Service Manual

MG125a

Model : MG125a

< AD6720 >

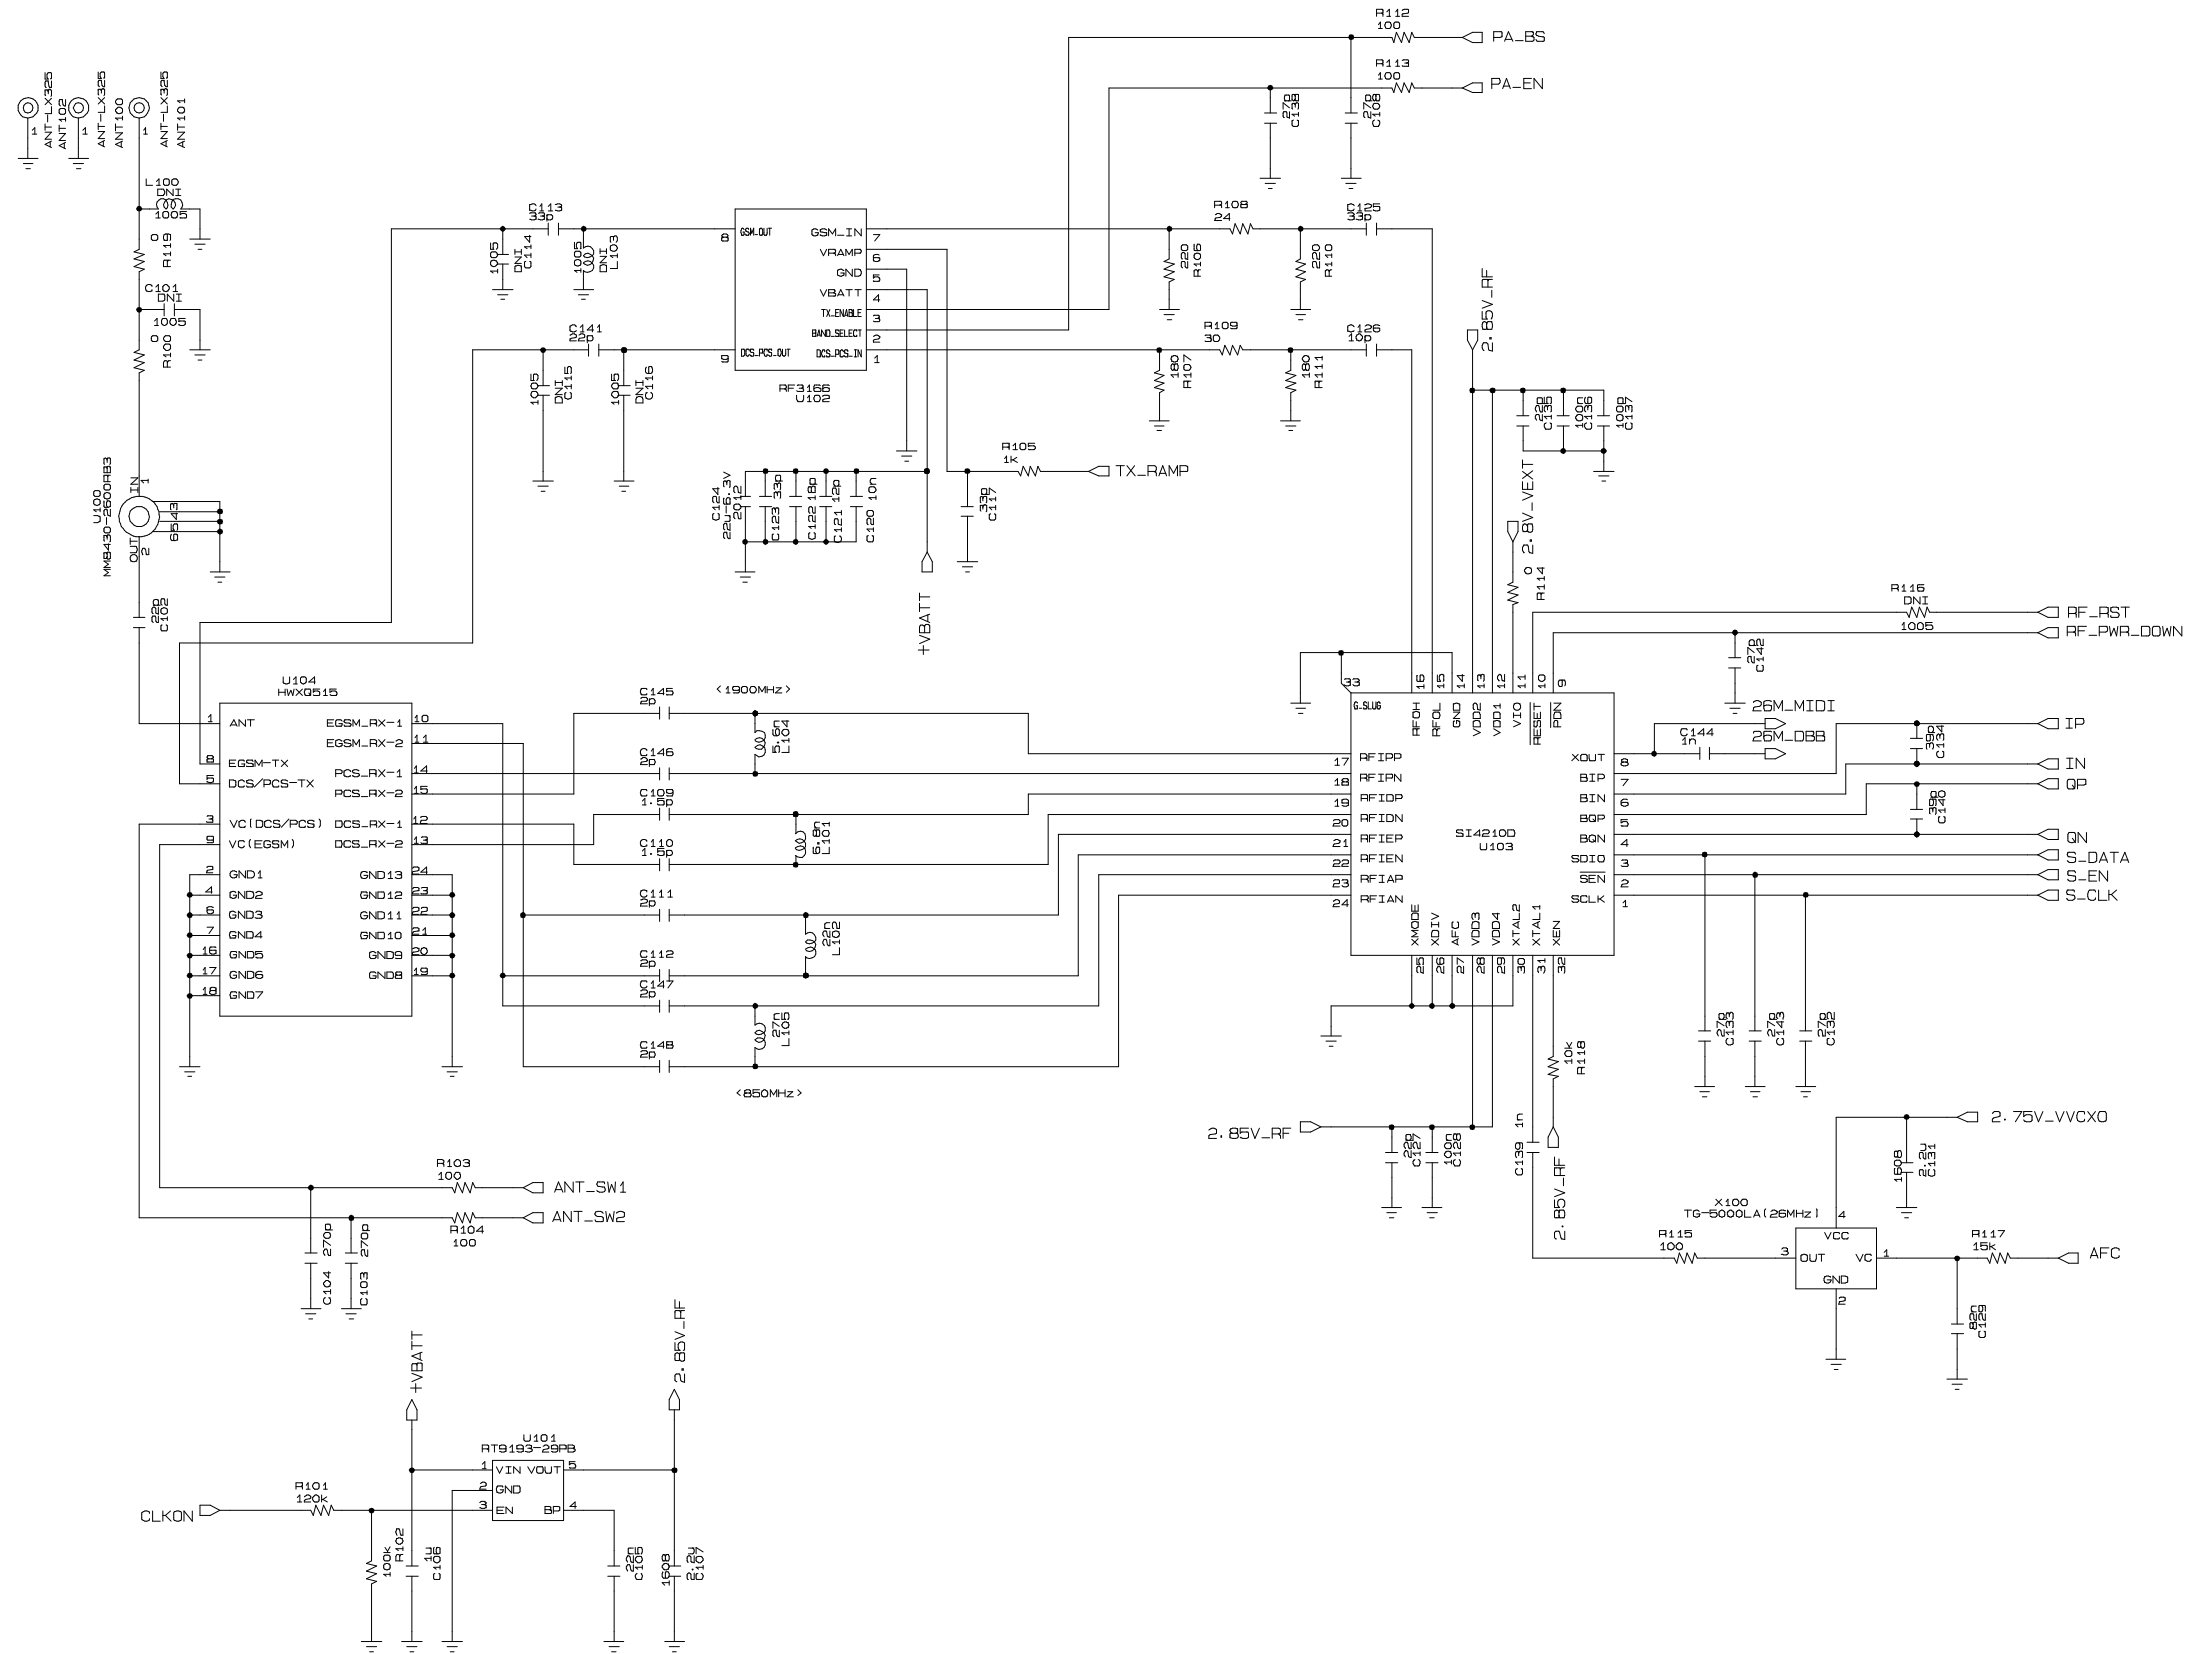
A->B
 ADD SHEET :
 26M_MIDI
 ADD :
 R116 (100->DNI)
 CHANGE :
 C100->R119
 L100 (4.7n->DNI)
 C101 (1p->DNI)
 B->C
 C145, C146
 (0.75p->2p)
 L104 :
 (8.2n->5.6n)
 C111, C112 :
 (1.5p->2p)
 C147, C148 :
 (1p->2p)
 L102
 (27n->22n)
 L105
 (33n->27n)
 C107
 (4.7u->2.2u)
 R101 (0->33K)
 ADD : Q100
 C105 (10n->22n)
 C->D
 CHANGE :
 R101
 (33K->120K)
 DELETE :
 Q100

< MEMORY >

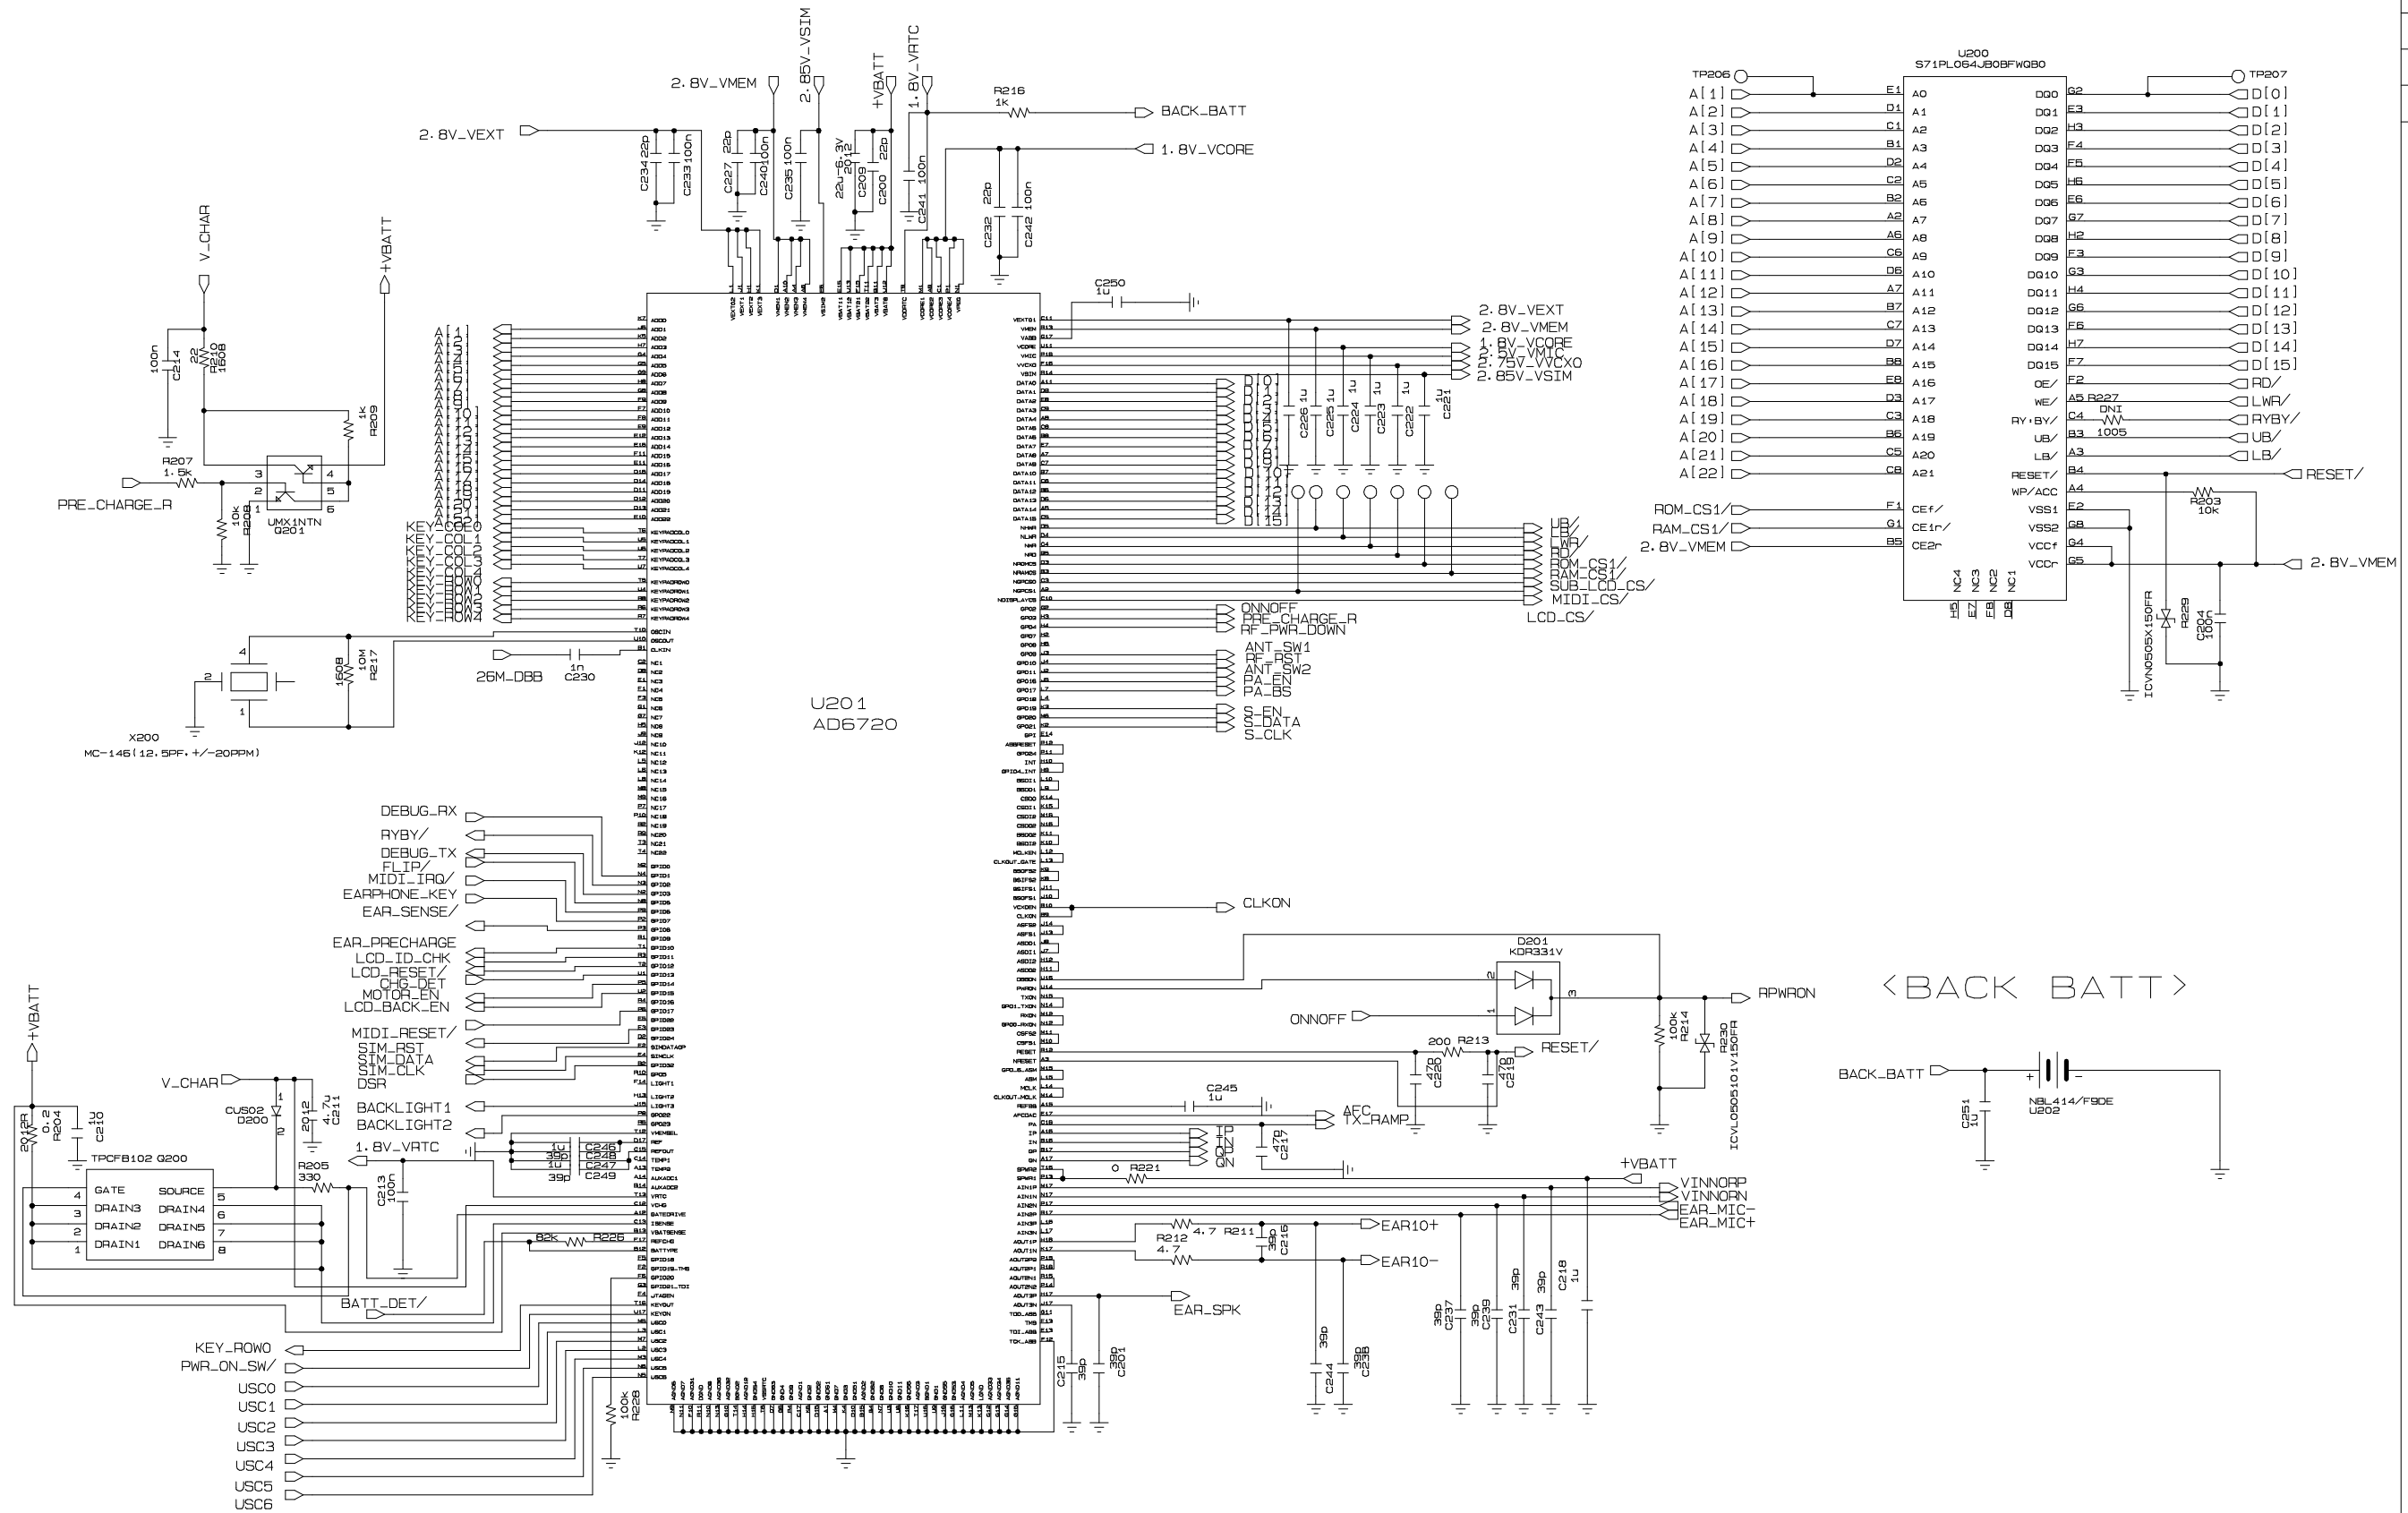
- A->B
 DELETE SHEET :
 SPK_P SPK_N
 DELETE :
 R224 R202
 R200
 C202 : C203
 C205 : C206
 C207 ;
 CHANGE :
 C204
 (10u->100n)
 C208->R229
 ADD :
 R228
 C251 (1u)
 B->C
 ADD :
 R230

<MIDI PART>

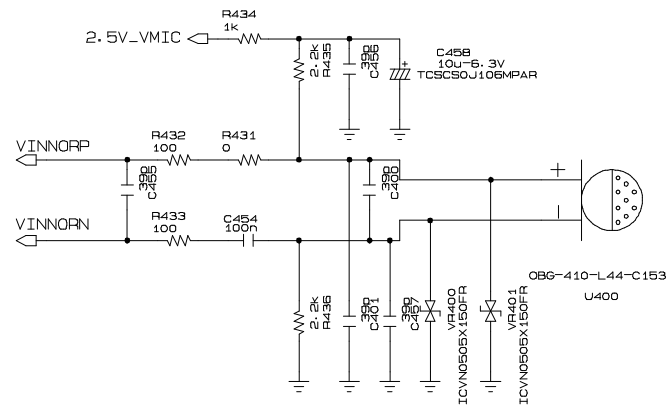
A->B
 ADD SHEET :
 MIDI_EAR_SPK
 ADD :
 C327
 R346(0)
 R347(DNI)
 CHANGE :
 R327->C328
 C316 :
 (10n->39p)
 R336 :
 (100k->33k)
 B->C
 C302
 1u->2.2u
 ADD : L300
 R348(100K)
 CHANGE :
 U302
 C->D
 ADD :
 R349(3.9K)
 CHANGE :
 R312
 (1K->3.9K)

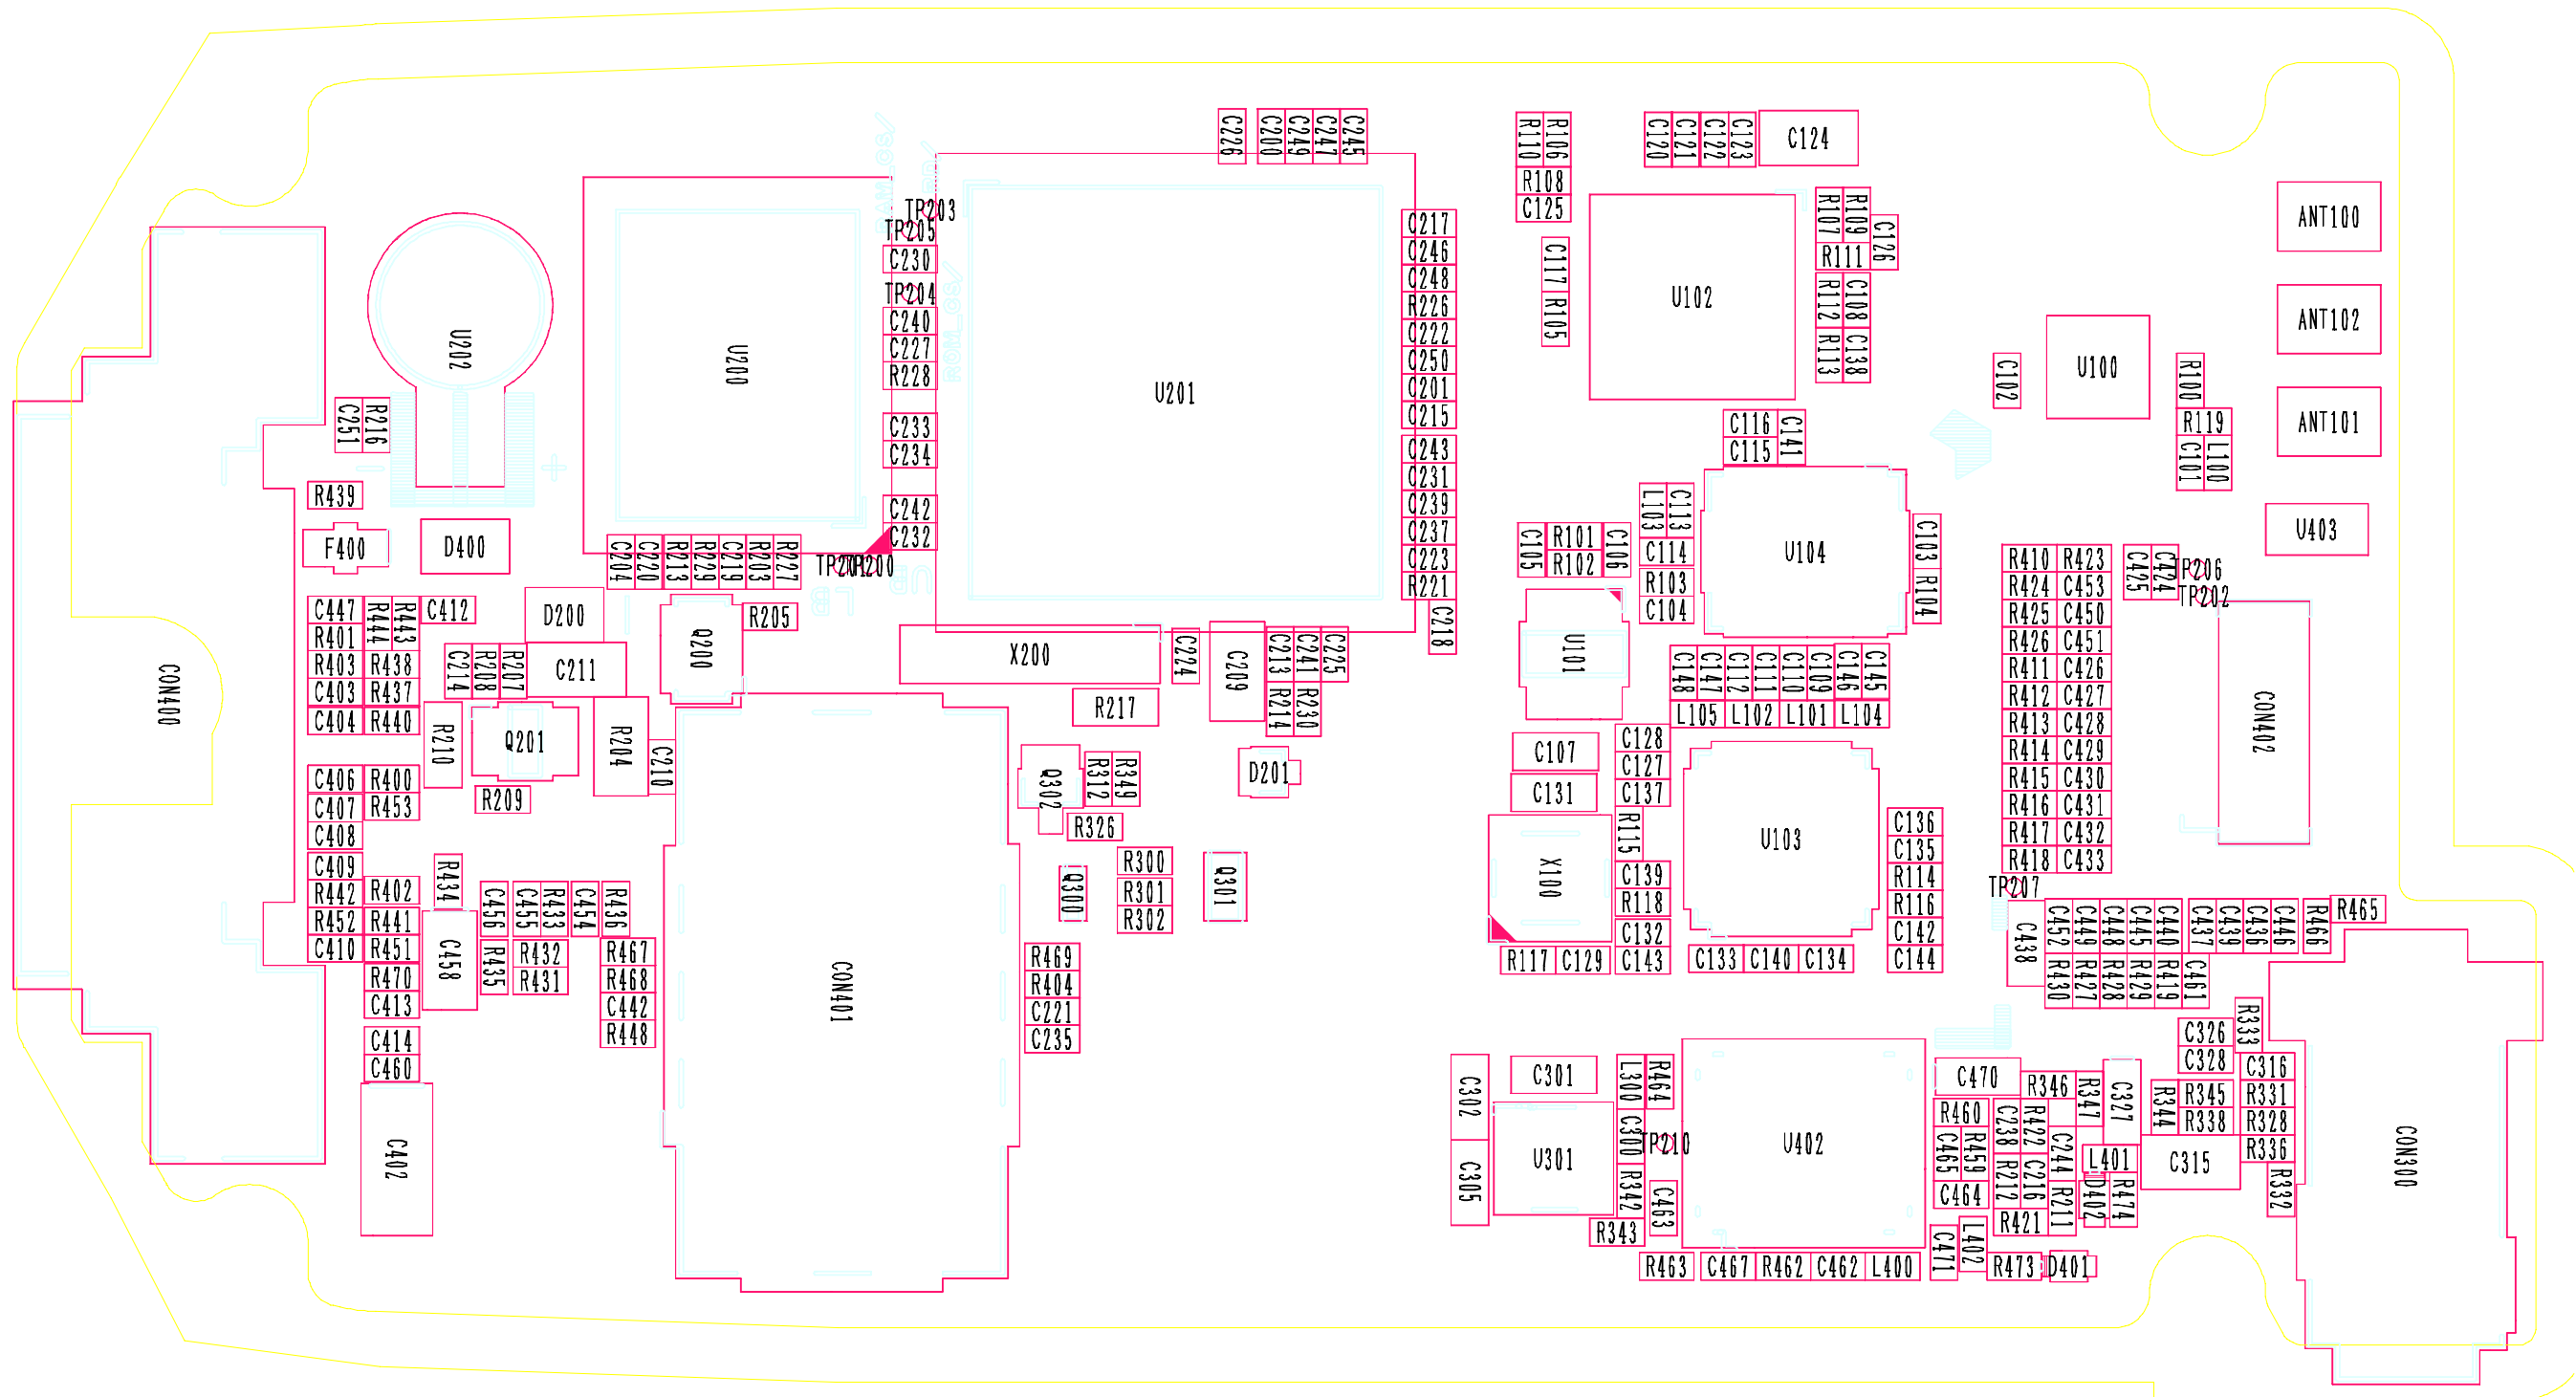
A->B

ADD :

MIDI PART
TERMINAL PAD
DELETE :

AUDIO AMP
B->C

ADD :

R463, R470
C473, C474
CHANGE :

C472->R464
C434->R465
C435->R466
C444->R467
C443->R468
C441->R469

C->D

DELETE :

C473, C474

CHANGE :

C412
(1n->0.1u)
C413
(33p->0.1u)

D->1.0

ADD :

R473 R474
R475 R476
